DESIGN CERTIFICATE

and to be erected at ...LOT BETHLEHEM HEIGHTS

PROPOSED RESIDENCE by Jock Holdings
Lot 26 BETHLEHEM HEIGHTS TAURANGA

SITE LAYOUT PLAN

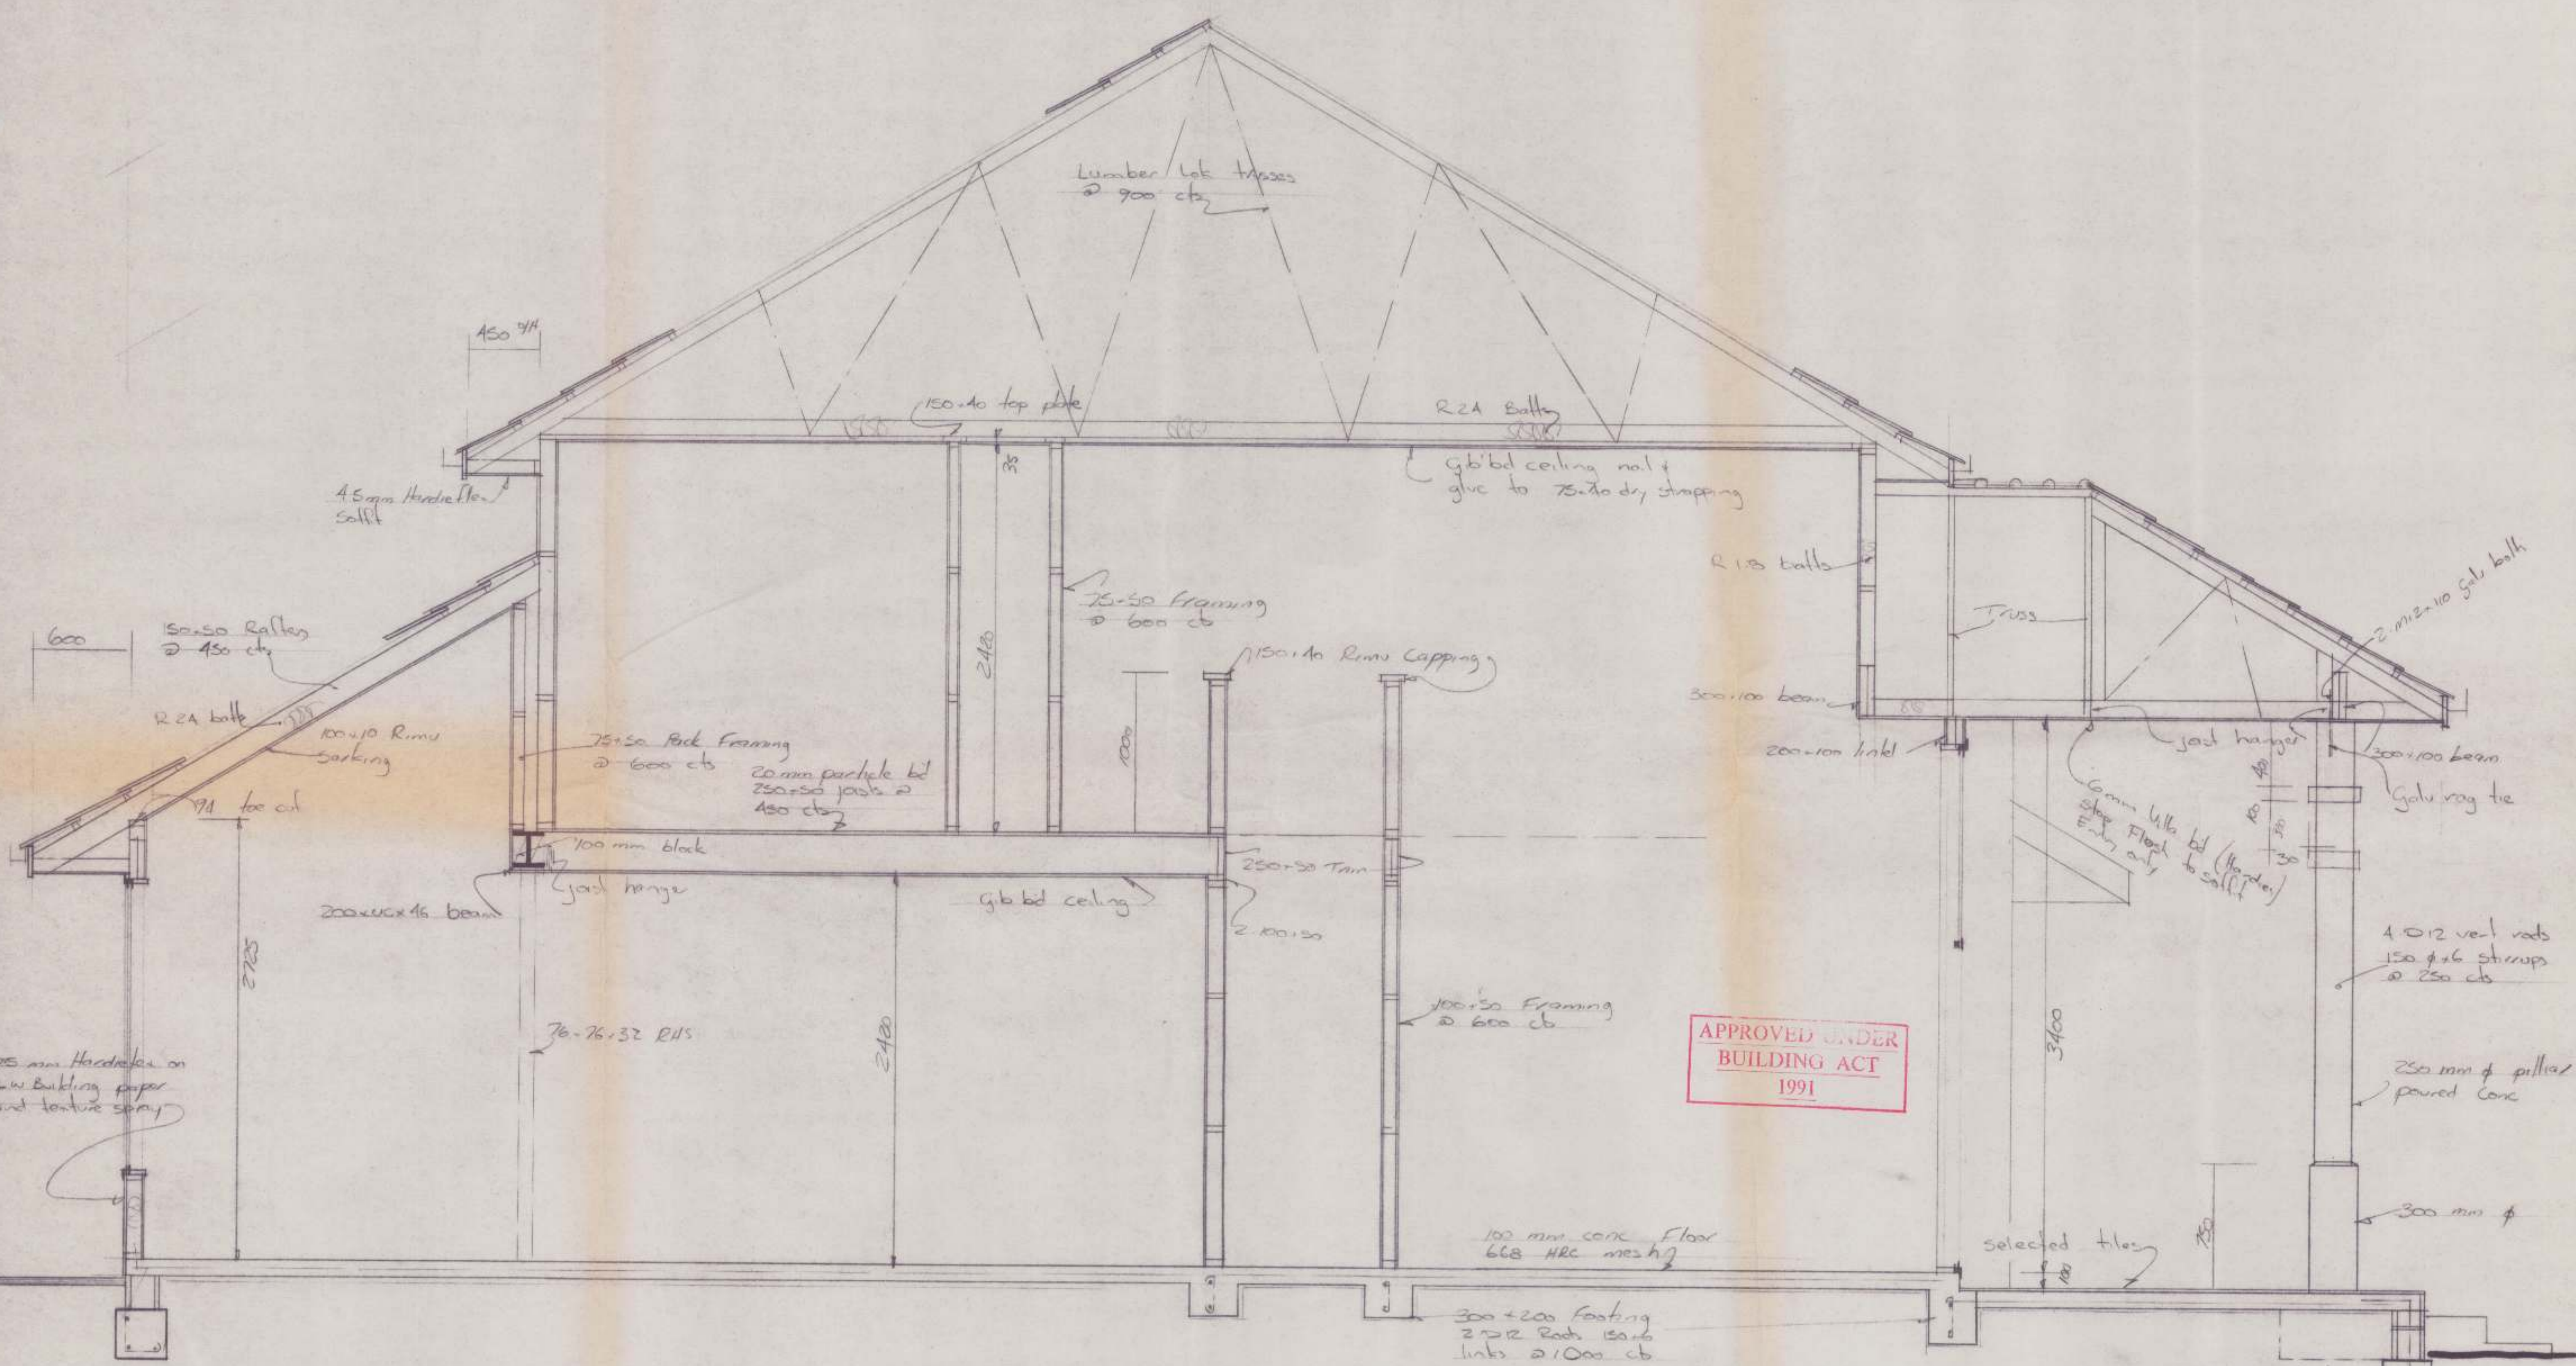
- ① In this zone the front yard requirement is 5m. The site plan shows only 4.6m. Could you please amend the plans to comply.
- ② Maximum height in this zone is 8m and it is measured above ground level - not averaged as in the Kawarua City section of the District Plan. I have enclosed an explanatory diagram. The north and south east elevation exceed the 8m maximum. Could these also be amended to comply.

Amendment Plans Received
17/6/90.
